As-built Baseline Monitoring Report

Bear Swamp Stream & Wetland Mitigation Project

RE: Response to Draft As-Built Baseline Monitoring Report (MY0) Comments dated June 7, 2021
Bear Swamp Stream & Wetland Mitigation Project
Lumber River Basin – CU# 03040203 - Robeson County, North Carolina
NCDMS Project # 100054, Contract # 7516

NC DEPARTMENT OF ENVIRONMENTAL QUALITY
 DIVISION OF MITIGATION SERVICES
 1652 MAIL SERVICE CENTER
 RALEIGH, NC 27699-1652

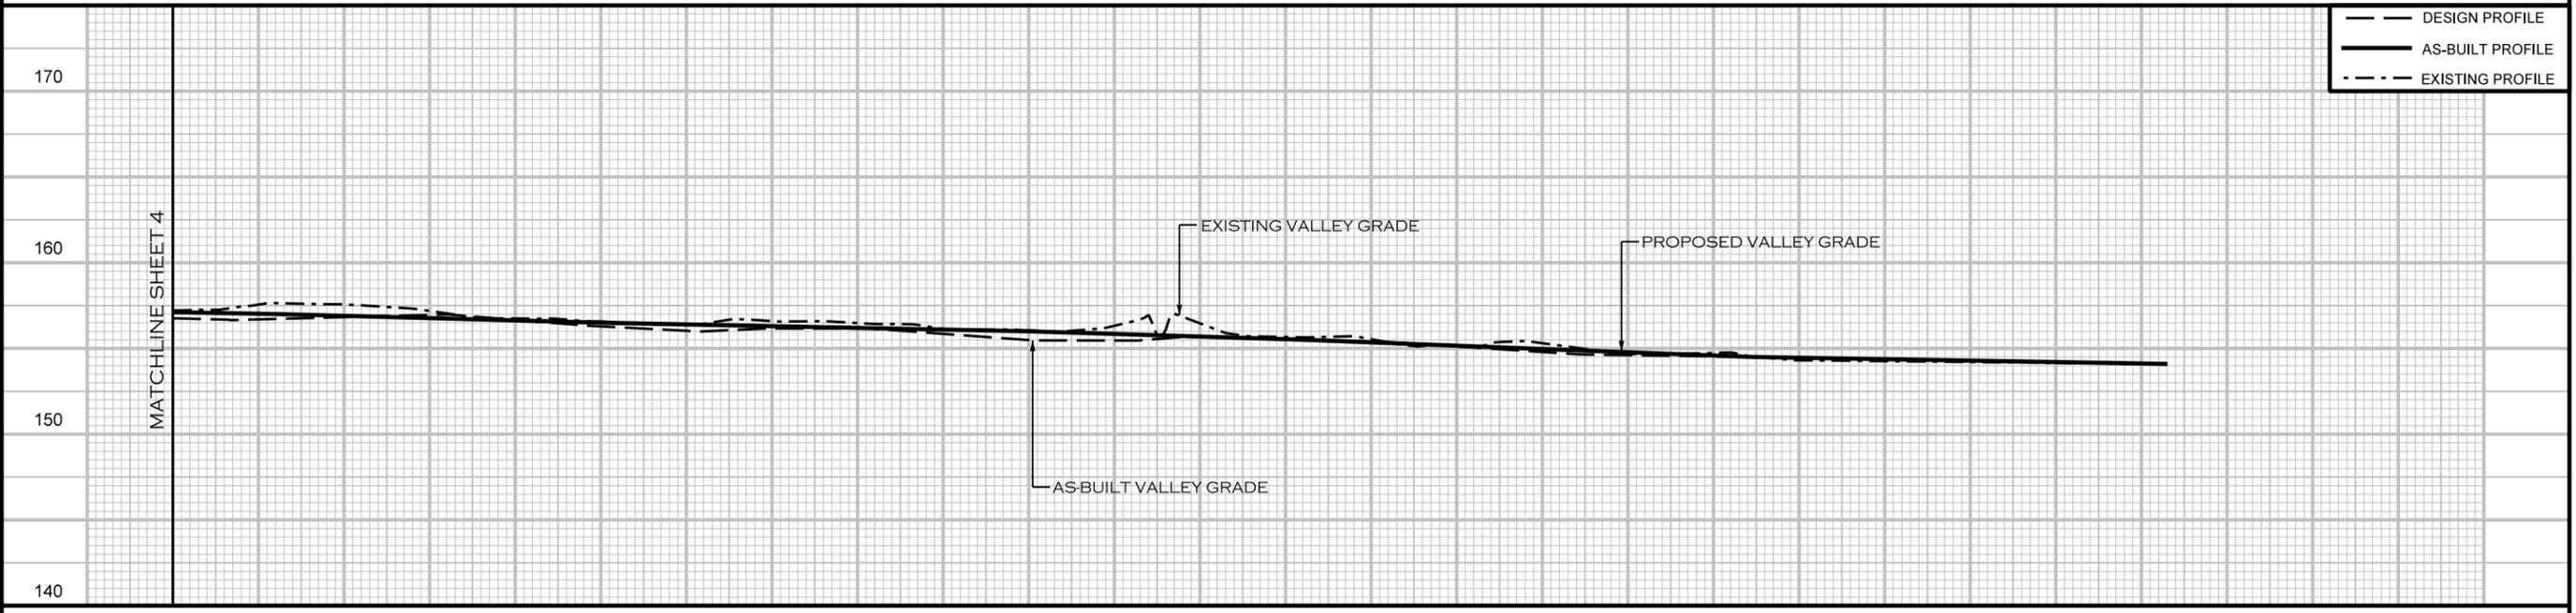
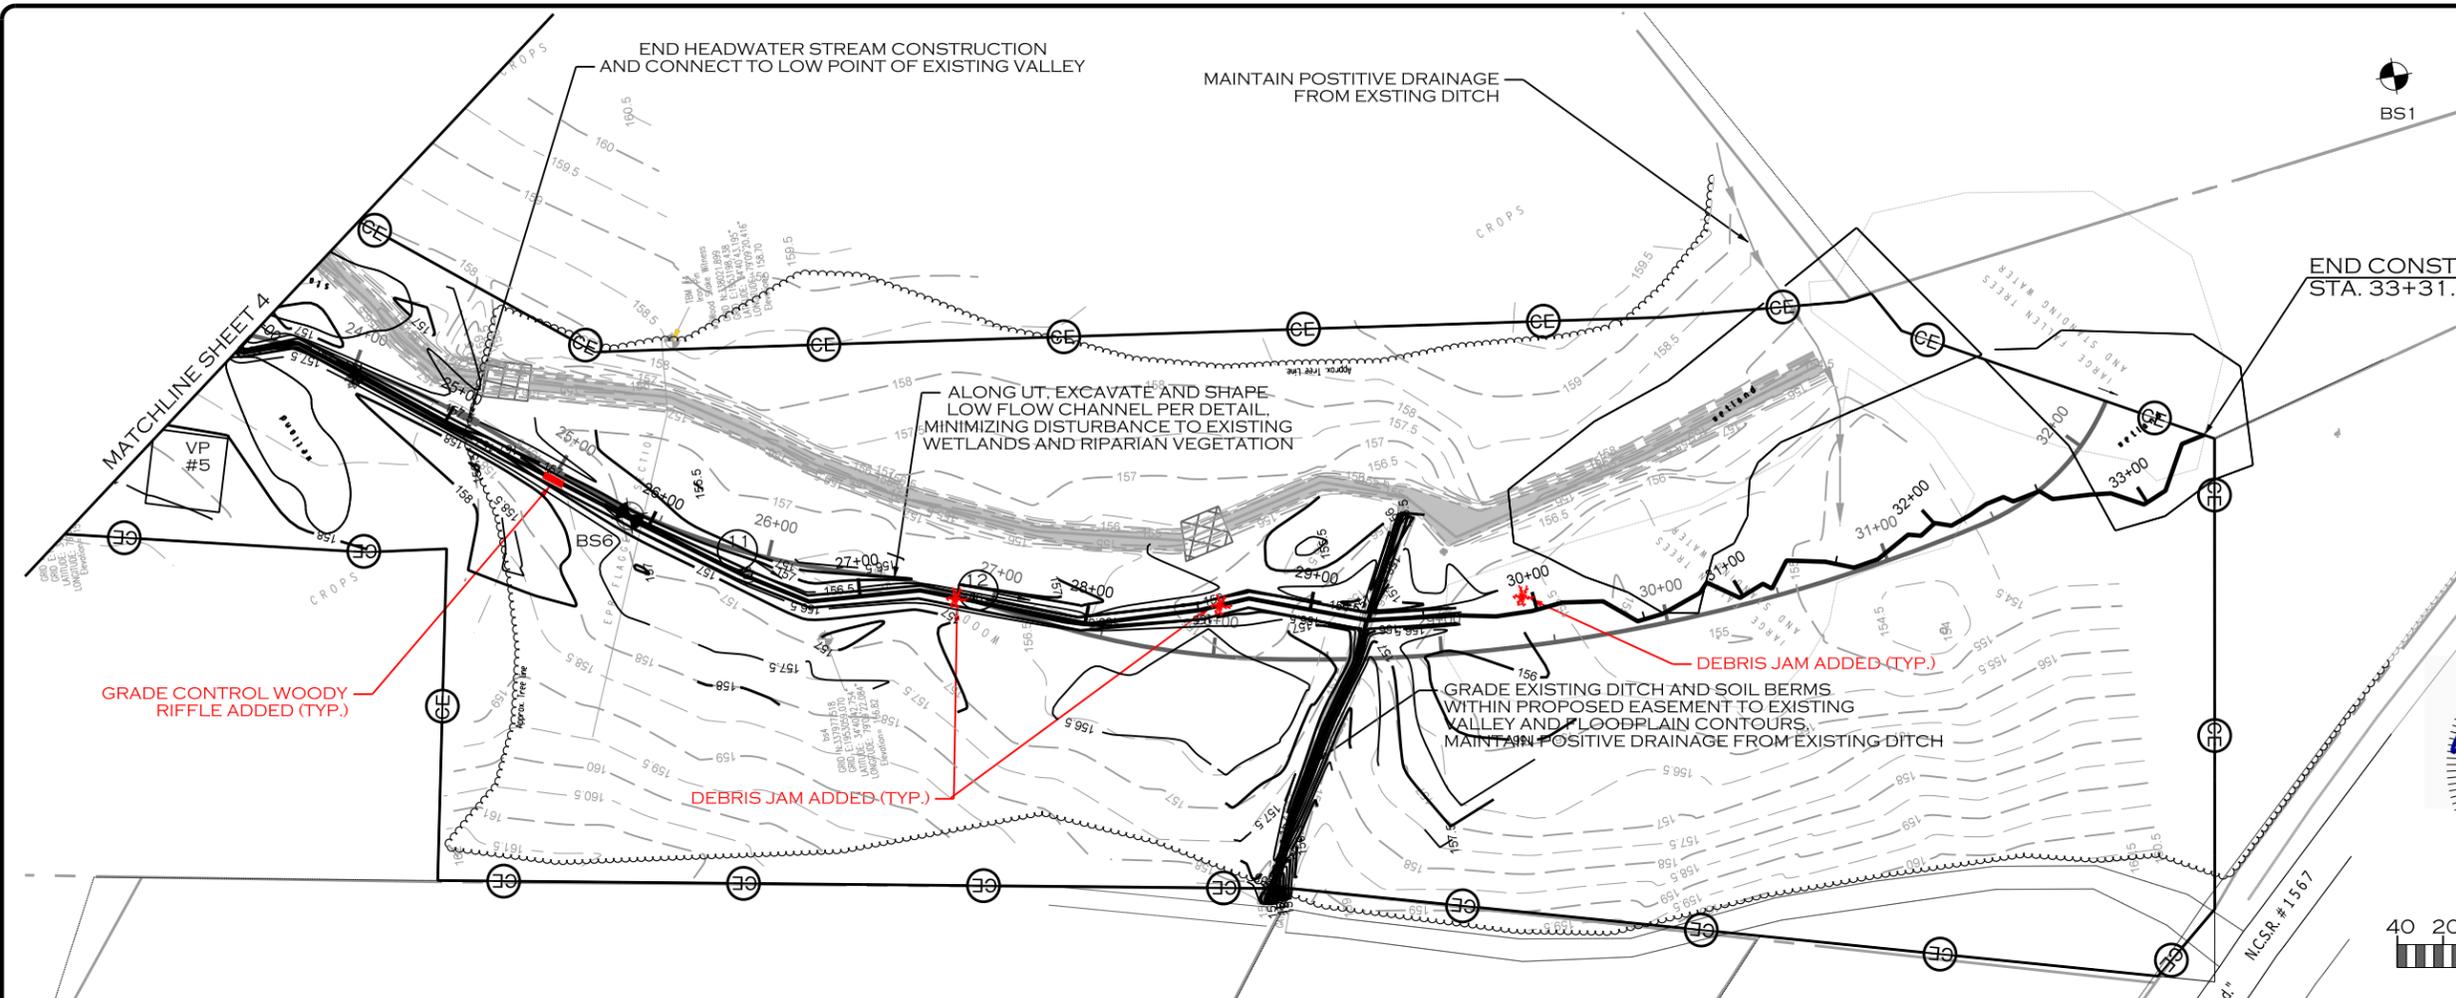
- *Long pro is showing on drawings, but difficult to see because of scale and background. Can the previous ditch depth be graphed to show elevation change and background turned off?*

- **The vertical scale on the profile was increased on sheets 3, 4, and 5 to improve legibility. Where the previous ditch ties in with the existing ground on sheet 5 the elevations are so similar that increasing the scale and/or turning off the background does not greatly improve legibility.**
